GEORGETOWN-SCOTT COUNTY PLANNING COMMISSION

AGENDA

November 9, 2017

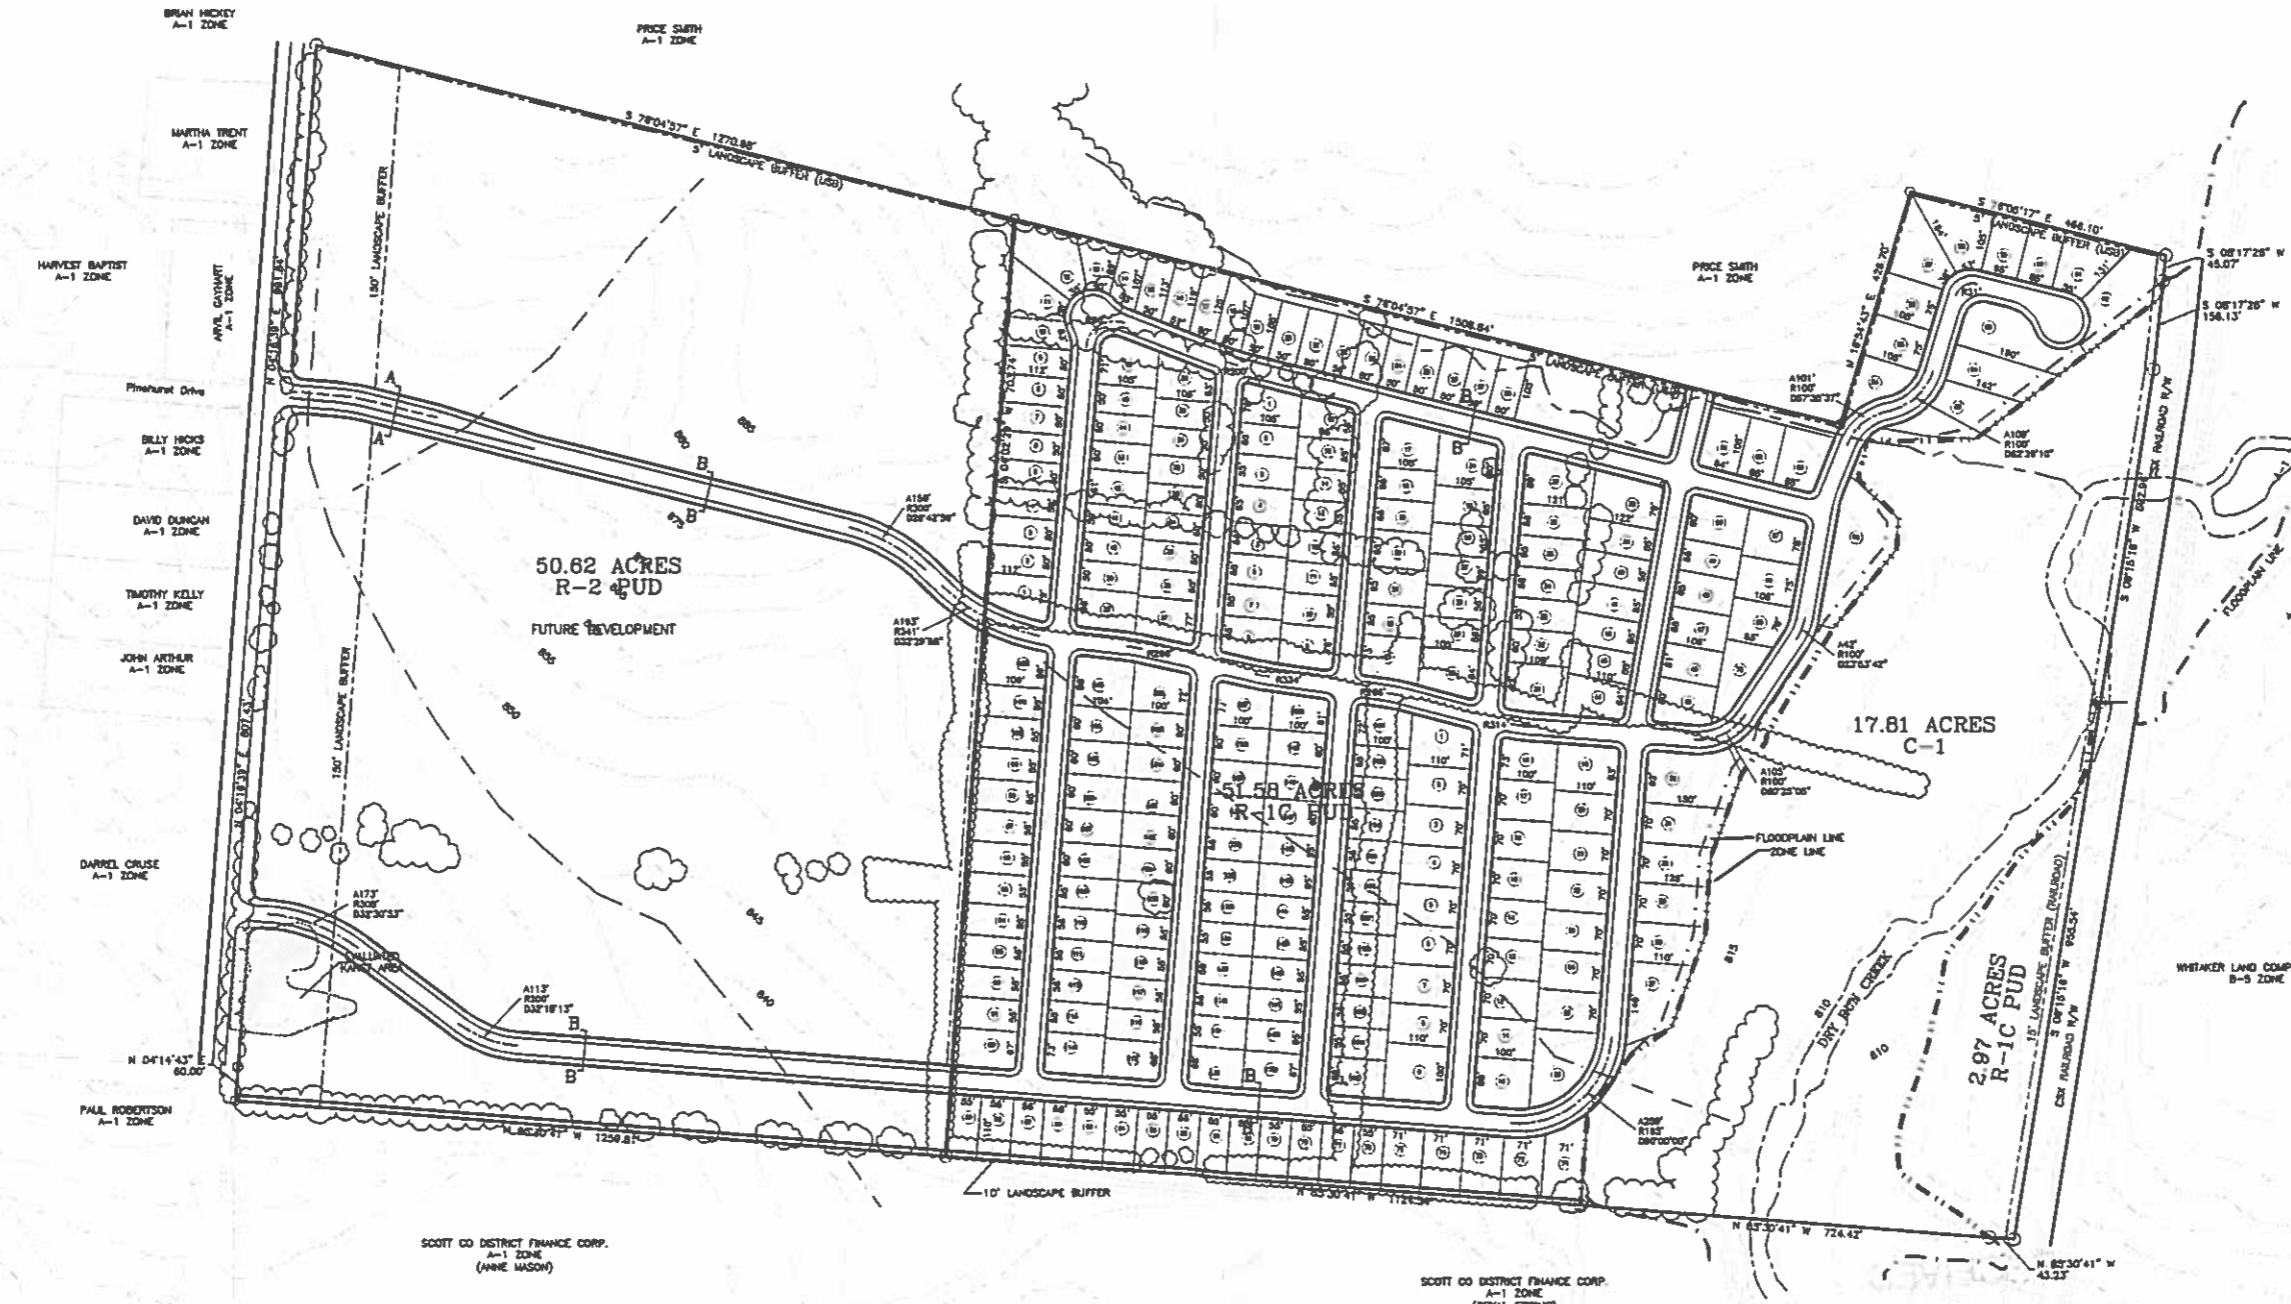
The main concerns with the concept plan are the proposed densities and the lack of detail shown in the multi-family area. The density is not in character with previously approved residential development at the edges of the Georgetown Urban Service Boundary. The lack of detail in the plan does not help to alleviate concern with the proposed density in this location. It is not recommended that an R-2 PUD designation be applied to a blank slate concept plan.

building line, with 30' front, 10' side and 25' rear setbacks. The smallest lots shown are 50' x 105'. The majority of lots are under the minimum size and width required in the R-1C district. Although this is only a concept plan, a typical planned unit development concept plan would provide community benefits in the form of open space, trails and or community amenities or an overall balance in lot sizes to justify the PUD designation. By balance in lots sizes, it is meant that overall the lots would average near 7500 square feet in size and 70' in width, with an equal balance over and under.

Stub street connections are shown on the concept plan, three to the north and two to the south. A turn around or school drop off should be provided for the schools. Details can be worked out at time of Preliminary Development Plan or Subdivision Plat submittal. The residential areas will not be connected through to adjoining areas but are landlocked by floodplain along Dry Run Creek and the Norfolk Southern Rail line to the east and Scott County school campuses to the south.

The applicant is proposing open space along US 25, along a tributary of Dry Run Creek through the single-family lot area and a large area of floodplain on the east side of the farm. No trail is shown on the revised plan. It is recommended that any future proposed walking trail connections being shown in the open space areas be a minimum of 8' in width. Hard surface rather than mulch is preferred.

3. Preservation of the existing tree lines where practical. 15' landscape buffer and tree preservation areas shall be provided around perimeter of the site and between R-1C and R-2 areas. A 150' landscape buffer with landscape design and number and type of plantings to be determined at time of Preliminary Development Plan submittal shall be provided along US 25.

**PRELIMINARY DEVELOPMENT PLAN
 TRI-VILLAGE STORAGE
 250 CONNECTOR ROAD
 SCOTT COUNTY, KENTUCKY**

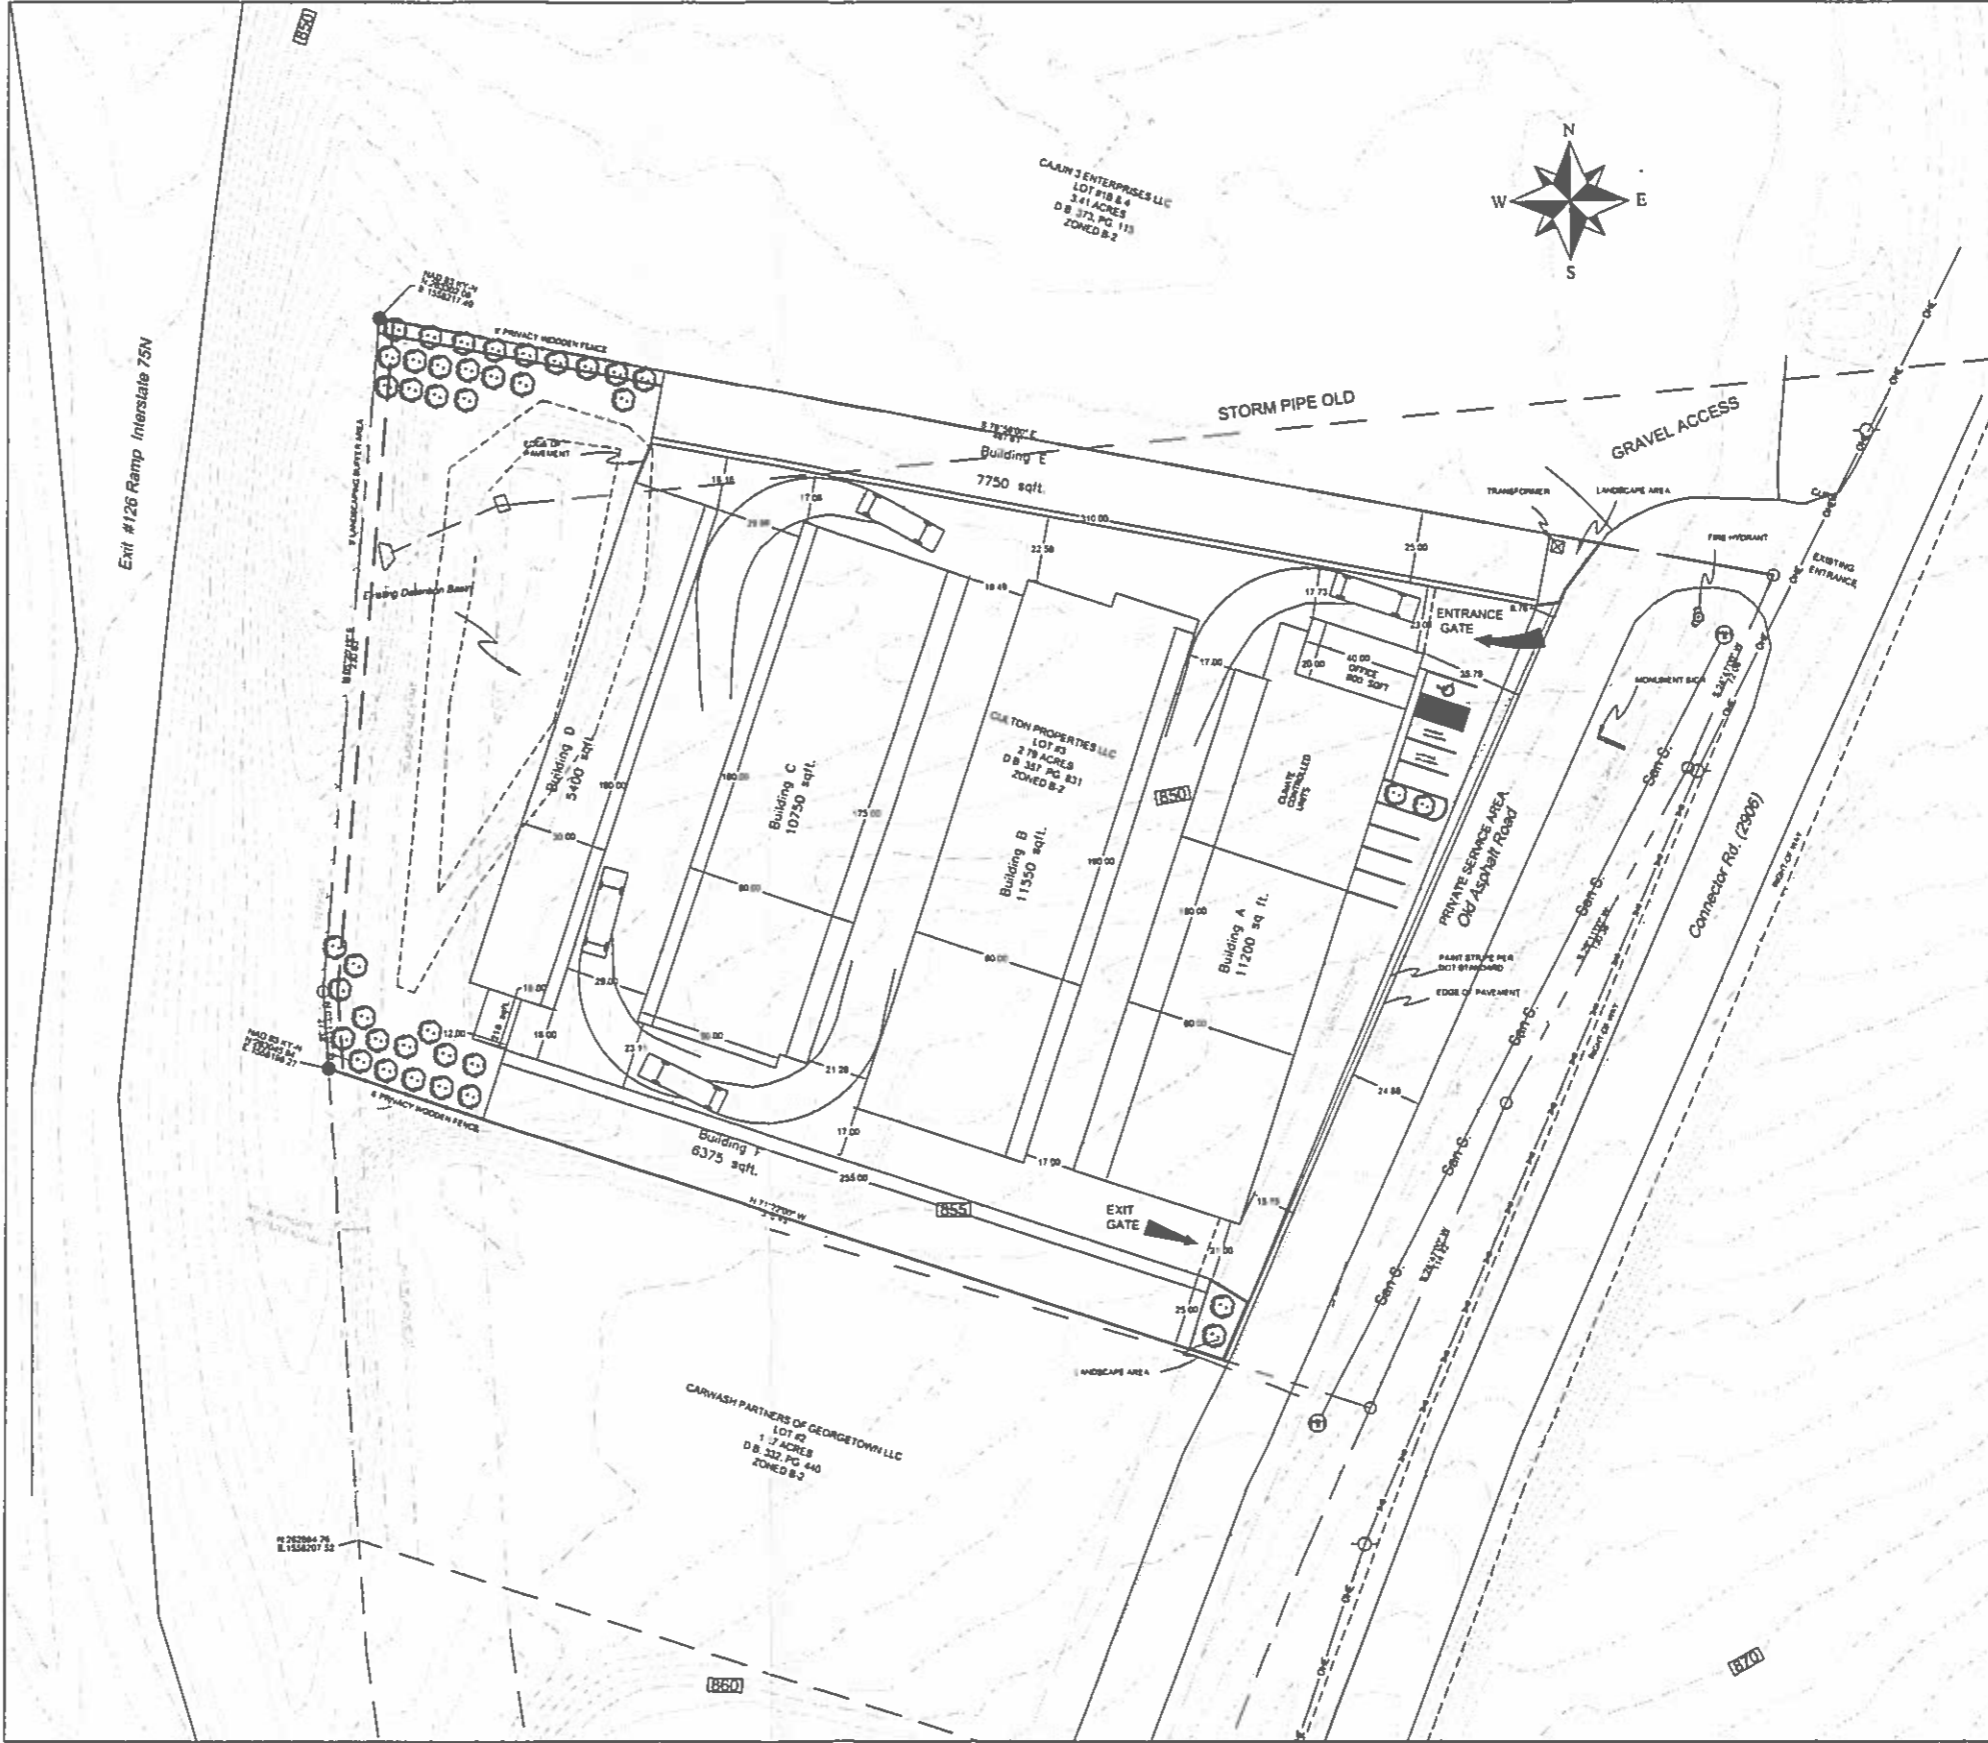
Driveways & Access: Access to the Project Site is from an access road on the western side of Connector Road. From the site plan, the Applicant intends to have open ingress/egress along the front of the property. Section 1005 (C.2) of the *Subdivision & Development Regulations* states, "street entrances to commercial developments shall be no wider than ¼ of the lot width up to a maximum width of 40 feet." Subsection C also goes on to require barriers to prevent "random vehicular access." There needs to be a more defined entrance and exit for vehicles accessing the Project Site to ensure the safety of drivers and pedestrians using this access road. Curbing and/or a landscaped area should be included to better define the access road from the parking area. This particular layout does not screen the vehicular use area from the right-of-way of either the access road or Connector Road.

Stormwater: There is a large detention basin proposed for the Project Site. The plan shows a stormwater pipe extending under proposed buildings on the Project Site. This pipe will need to be rerouted, or the buildings will need to be adjusted so the pipe does not run underneath buildings. A Final Stormwater Management Plan must be submitted and approved by the Planning Commission Engineer meeting all requirements of the Georgetown Stormwater Manual prior to approval of the Final Development Plan.

3. The stormwater pipe shown on the Preliminary Plan will need to be rerouted or the building layout adjusted to ensure the pipe does not run under any of the proposed buildings.
